Meeting Agenda Design Review Board

**Appeal to Landscape
Buffer Standards
for
BTU Shady Lane
Substation
AWV2025-000028**

SUMMARY: The applicant is requesting the Board to modify the requirement of a 20-foot wide landscape buffer and reduce it to a 15-foot wide buffer for the BTU Shady Lane Substation. While the existing substation is proposing to expand, there is additional developable area for the development to be redesigned and provide the required buffer. The applicant states that with the required 20-foot buffer it is not be possible for BTU to meet their required maintenance and operational electrical equipment safety clearances. The applicant is proposing to install an 8’ high wall, as opposed to the 6’ fence required, leave an existing wooden fence in place, and utilize existing trees to meet the UDO planting requirement within the buffer.

Name of Project: SEEKING A 15-FOOT LANDSCAPE BUFFER (AWV2025-000028)

**SEEKING A 15-FOOT
LANDSCAPE BUFFER**

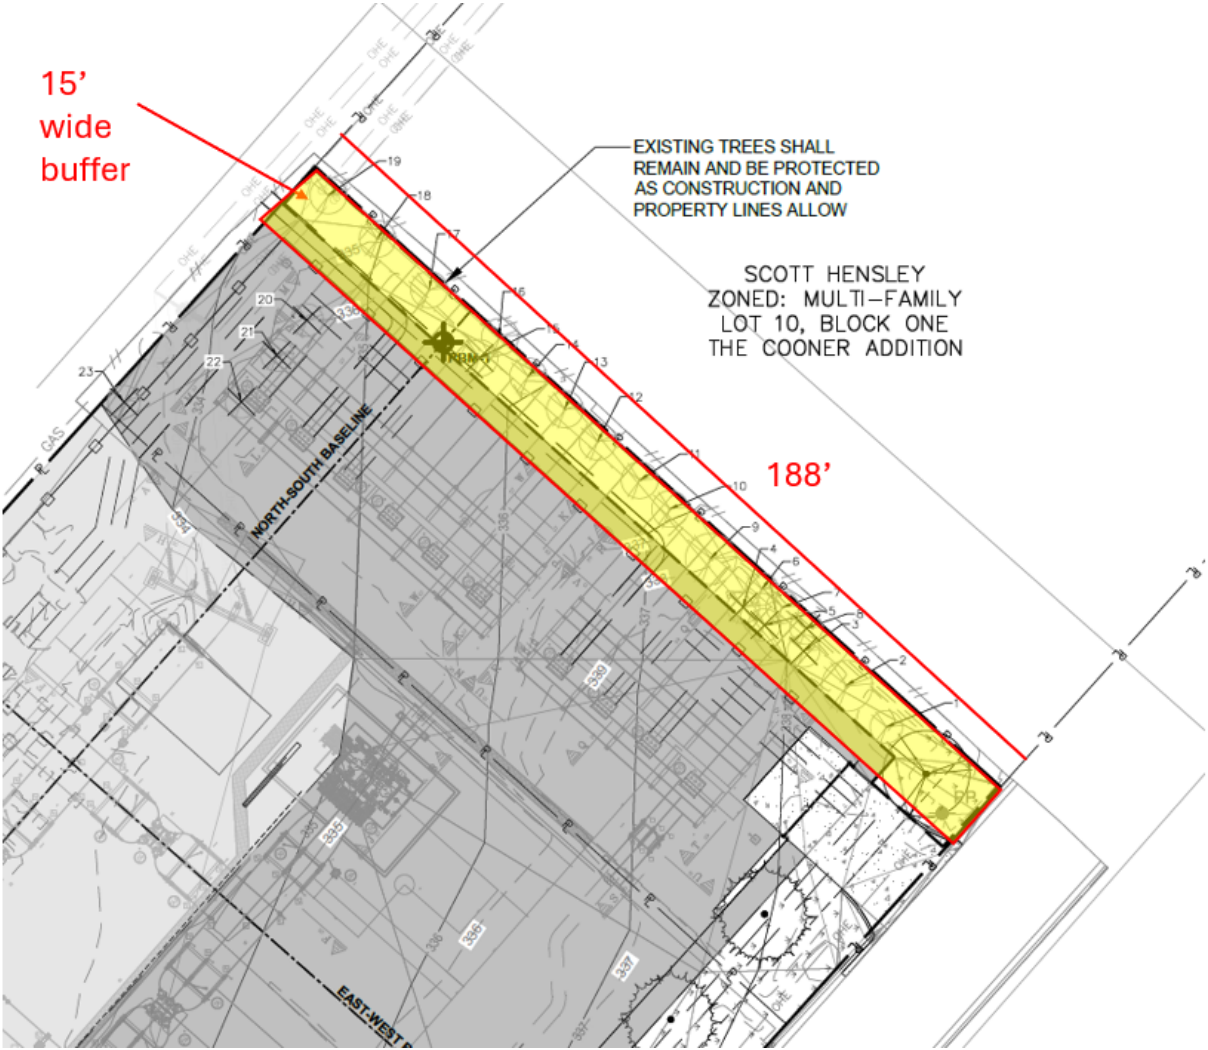
STAFF RECOMMENDATION: Staff recommends denial of this request. Requiring a larger buffer between the utility and the adjacent residential development would not negatively effect this development. Based on the proposal, while the existing substation is able to expand, it could be redesigned in order to provide the required area between these two uses. The purpose of the buffer is to not only provide a visual separation, but is also to help mitigate any negative impacts of adjacent land uses on existing or developing properties that are more intense. The applicant has proposed the buffer to be reduced to 15-feet, proposing to add a wall, keep the existing fence in place and utilize existing trees thus creating a visual barrier between the two uses. The existing trees within the buffer exceed the number of plantings required by Section 7.7.F. The reduced buffer may be injurious to the interest of adjacent landowners as the existing substation is proposed to double in size. Utilities are identified in the Specific Use Standards as needing to provide a 20’ buffer and reducing the physical distance between the existing residential use and the utility substation does not meet the intent of the buffer section of the UDO. There is a unique condition not normally found due to an existing utility facility located between existing developments that is proposing to expand to provide services. The proposed site plan for the BTU Shady Lane Substation will be designed to also include streetscaping along Cooner Street. As stated by the applicant a hardship exists that “without the additional five feet of space, it will not be possible for BTU to meet their required maintenance and operational electrical equipment safety clearances.” They have also indicated that “While designing the Project, every effort has been made to maximize the space available while meeting the goal of the expansion and meeting College Station landscape and ordinance requirements.”

Reduction of the 20-foot setback to 15 feet

Without the additional five feet of space, it will not be possible for BTU to meet their required maintenance and operational electrical equipment safety clearances. This presents a significant concern, as it directly impacts operator safety and the overall reliability of the electrical grid. The space between the distribution bays and the transformer riser structure is essential for BTU personnel to safely operate a telehandler, which is used to lift and relocate circuit breakers during routine maintenance. The inability to perform these tasks safely and efficiently could result in increased risk to both personnel and critical infrastructure.

SHADY LANE SUBSTATION LANDSCAPE PLAN

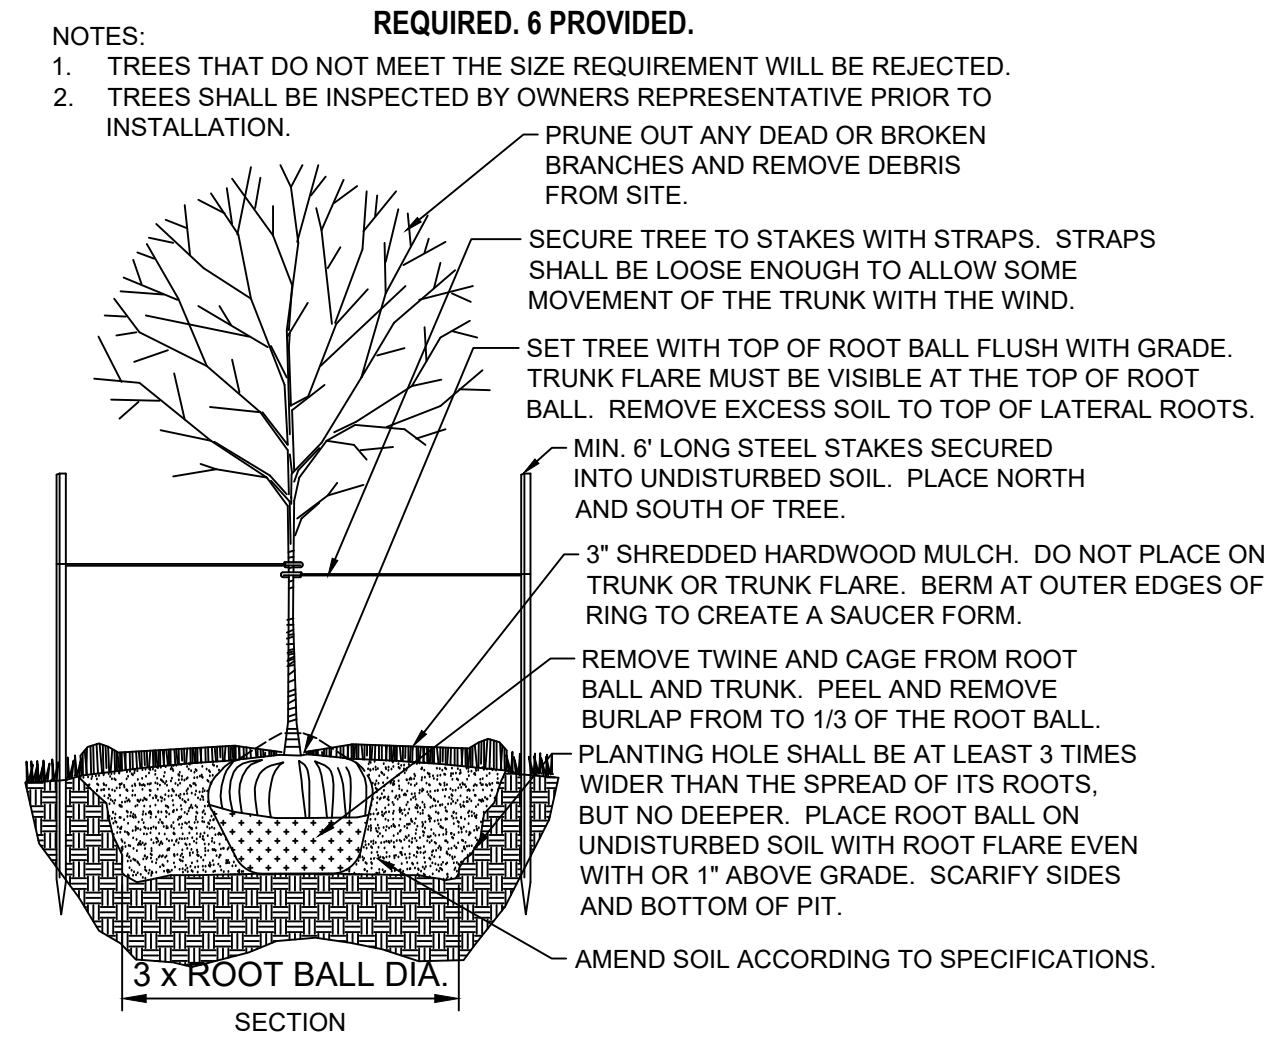
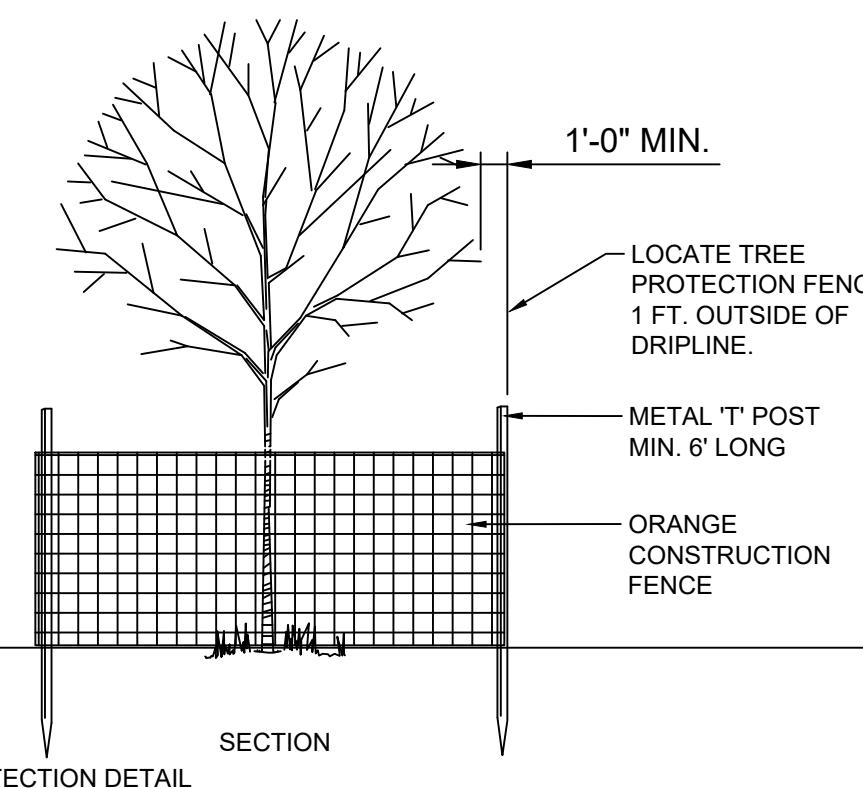
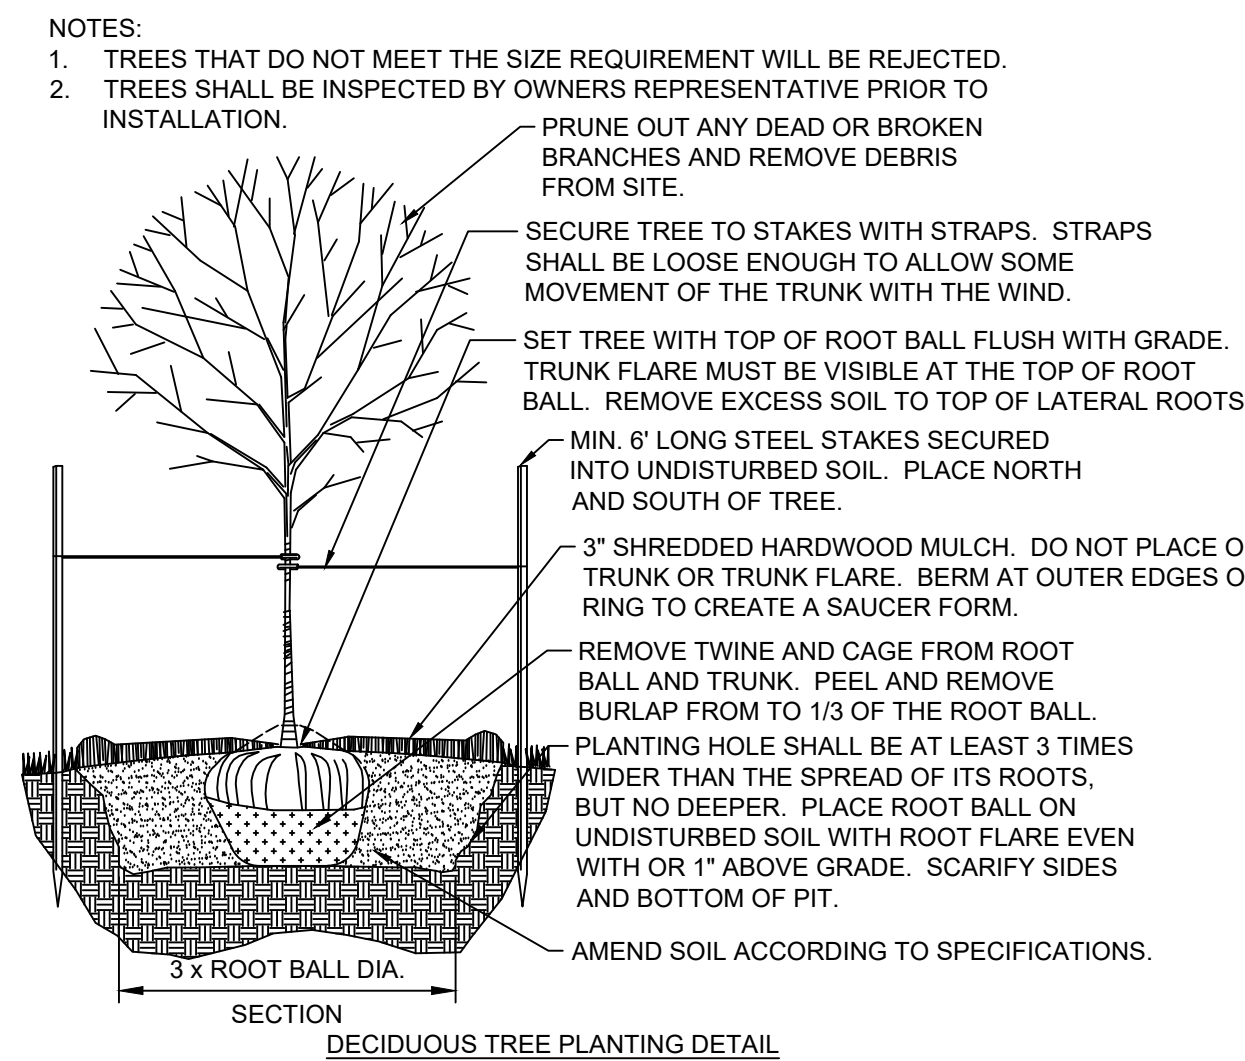
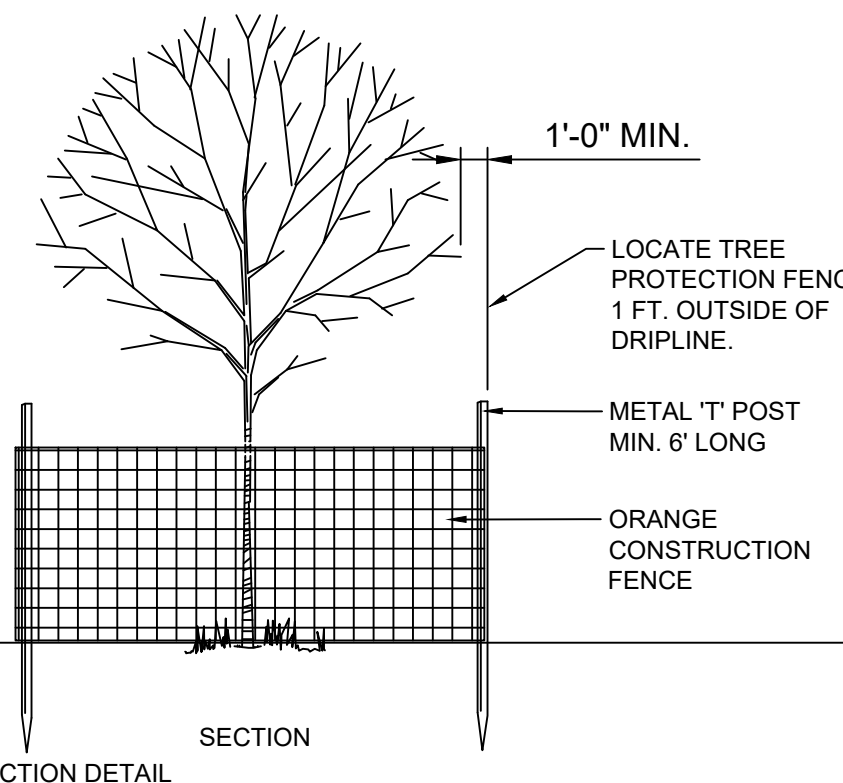
BUFFER YARD 188 LF.
(188/15)= 12.53 NON CANOPY TREES + (181/25) = 8 CANOPY TREES
SOLID WALL REDUCE BY 50%
REQUIRED: 7 NON CANOPY TREES + 4 CANOPY TREES
PROPOSED: (14) EXISTING CANOPY TREES + (1) NON CANOPY TREE, SEE TABLE THIS SHEET.
SOD AT PERIMETER
